UNITED STATES PATENT AND TRADEMARK OFFICE

10/553,478

Office Action Summary	Application No. 10/553,478	Applicant(s) WATANABE ET AL.	
	Examiner ALEXANDER B. COMLEY	Art Unit 3746

DETAILED ACTION

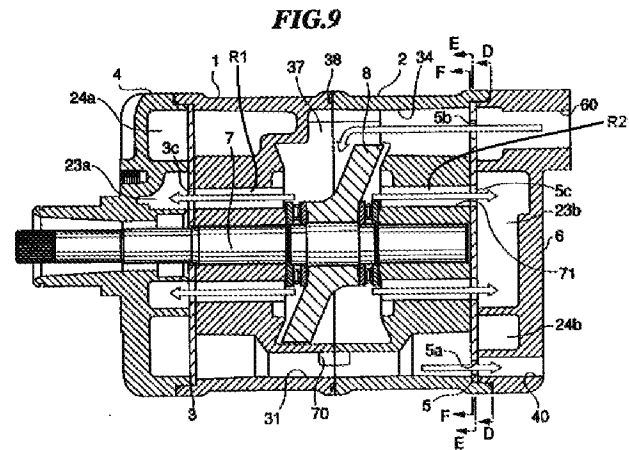
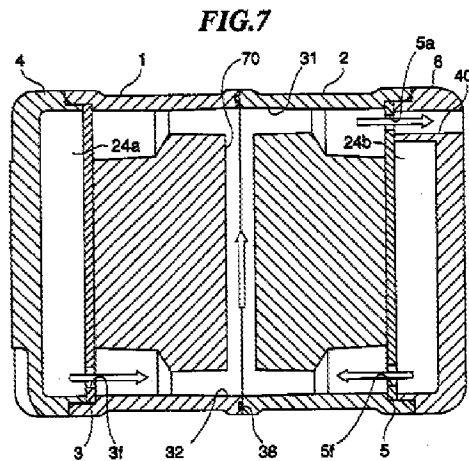
In regards to Independent **Claim 1**, and with particular reference to Figures 7 & 9 shown immediately above, Arai et al. discloses:

(1) A swash plate compressor, comprising: a housing having formed therein cylinders (1, 2); a drive shaft (7) rotatably supported at said housing; a swash plate (8) that is housed inside a swash plate chamber (37) formed at said housing and rotates as one with said drive shaft (7); and pistons (12) that slide reciprocally inside the cylinder bore (1, 2) as said swash plate (8) rotates, wherein a front-side intake chamber (23a) and a rear-side intake chamber (23b) communicating with said swash plate chamber and disposed to the front and to the rear of said swash plate chamber (37) along the axial direction, in which a working fluid to be guided into said cylinders (1, 2) is stored, a front-side outlet chamber (24a) and a rear-side outlet chamber (24b) disposed to the front and to the rear of said swash plate chamber (37) along the axial direction, in which the working fluid having been compressed by said pistons (12) is stored, a first gas passage (34) and a second gas passage (33) extending along the axial direction,

a third gas passage (31) formed substantially symmetrical to said first gas passage relative to a plane containing said drive shaft (7), a fourth gas passage (32) formed substantially symmetrical to said second gas passage (31) relative to the plane containing said drive shaft (7) and communicating with said second gas passage (33) and an external component (an evaporator, not shown) that includes an intake port and an outlet port to be connected to piping, are all disposed at said housing; wherein said first gas passage and said third gas passage communicate with said swash plate chamber; wherein said first gas passage (34) or said third gas passage (31) is selectively made to communicate with said intake port (60) to supply the working fluid into said front-side intake chamber (23a) and said rear-side intake chamber (23b); and wherein either said second gas passage (33) or said fourth gas passage (32) is made to communicate with said front-side outlet chamber (24a) and said rear-side outlet chamber (24b) and said second gas passage (33) or said fourth gas passage (32), which is not in communication with said outlet chambers, is made to communicate with said outlet port (40).

As shown in the figures above, Arai et al. discloses a swash plate compressor for the compressing of a refrigerant gas in a refrigerant circuit. The compressor contains front- and rear-side inlet chambers, as well as front- and rear-side discharge chambers, for storing refrigerant gas in its un-compressed and compressed states, respectively. To begin, Arai et al. first describes the basic compressor structure by

(Column 4, Lines 15-32) Most importantly, however, is the structure of the four refrigerant passages (i.e. gas passages) that communicate with the intake, discharge, and swash plate chambers. In particular, Arai states "The refrigerant outlet passages 32, 33, communicate with discharge chambers 24a and 24b via ports 3f and 5f formed through a valve plate 3 and a valve plate 5, respectively, and the other refrigerant outlet passage 31 communicates with a discharge port 40 via a port 5a. Further, a guide passage 70 which communicates an intermediate portion of the refrigerant outlet passage 31 with an intermediate portion of the refrigerant outlet passage 32 extends in a junction of the cylinder blocks 1 and 2." (Column 4, Lines 34-43) In Arai's compressor, passage 34 acts as the refrigerant gas inlet passage, while passages 31-33 act as the refrigerant gas outlet passages (i.e. a total of 4 gas passages). Hence, it can be seen that first gas passage (i.e. either the first of third gas passage, as claimed) is selected to communicate with the intake port 40, while either the second or fourth gas

passage is made to communicate with the outlet port 60. More specifically, Arai discloses that the discharge passage that is NOT in communication with the discharge port is in communication with the outlet chambers. In particular, Arai states "According to the invention, since the cylinder block has the guide passage therein for communicating the intermediate portion of any of the at least two refrigerant outlet passages other than the one of the at least two refrigerant outlet passages being communicated with the discharge port, with the one of the at least two refrigerant outlet passages being communicated with the discharge port, refrigerant is permitted to flow from the former, which is not communicated with the discharge port, to the latter, which is communicated with the discharge port, whereby refrigerant is prevented from becoming standing within the any of the refrigerant outlet passages other than the refrigerant outlet passage communicated with the discharge port." (Column 2, Line 66 – Column 3, Line 11) Therefore, it can be seen that Arai contains Applicant's four claimed gas passages, and are structured in the same way.

4. In regards to dependent **Claim 2**, it can be seen in Figure 9 that relay passages (R1 and R2) are formed with the first and third gas passages (34, 31) in order to communicate the swash plate chamber with the front- and rear intake chambers (23a, 23b). Regarding dependent **Claims 3 and 4**, and with reference to Figures 7 & 9 above, as well as Figure 11 of Arai, it can be seen that valve plates are disposed between front- and rear-side cylinder heads (4, 6) in order to control the inflow and outflow of refrigerant gas. To begin Arai states "The refrigerant outlet passages 32, 33,
